SCHWEIZER SERVICE NOTICE

NOTICE NO. N-142.1

SUBJECT: INITIAL INSTALLATION OF PN 269A5194 MAIN ROTOR DRIVE RING GEAR CARRIER ASSEMBLY; MODIFICATION OF PN 269A5182 MAIN GEAR DRIVE UPPER HOUSING ASSEMBLY

Figure 1. Rework of Main Gear Drive Upper Housing Assembly, PN 269A5182

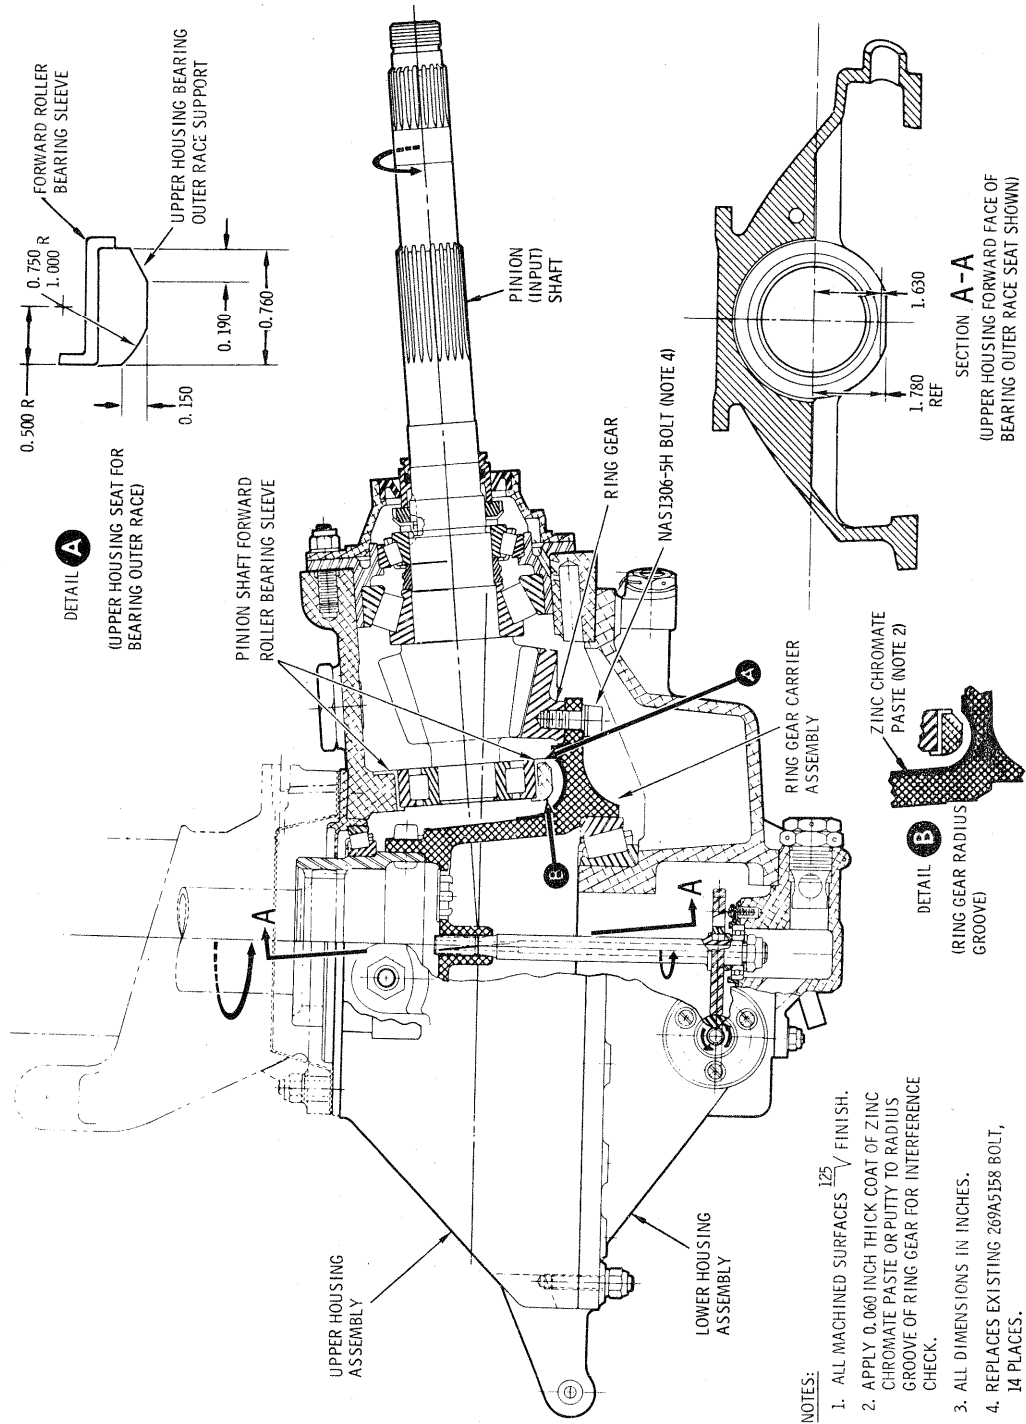
a. Locate rework area on the lower front face of the upper housing seat for the pinion forward roller bearing outer race. (See Figure 1.) Mill housing bearing support per dimensions shown; dichromate treat the reworked area of housing, per Basic HMI, Section 2.

b. Check for interference between the radius of the 269A5194 carrier and the reworked area of the upper housing assembly as follows:

1. With 269A5105 lower housing right side up on bench, position 269A5194 ring gear and carrier in place in lower housing.
2. Apply a 0.060 inch thick coat of zinc chromate paste (or putty) to cover full circumference of radius groove in ring gear, as shown in Figure 1.
3. Position reworked 269A5182 upper housing in place on lower housing; position 269A5114 cover (without 269A5102 shim) in place on upper housing.
4. While applying hand pressure on cover to preload bearings, rotate ring gear 360° several times; separate upper and lower housings and remove ring gear and carrier assembly.
5. Check coat of zinc chromate paste (or putty) for evidence of contact or interference between the upper housing and carrier assemblies.

If less than 0.030 clearance exists, repeat step a and step b.2 through step b.5 above.
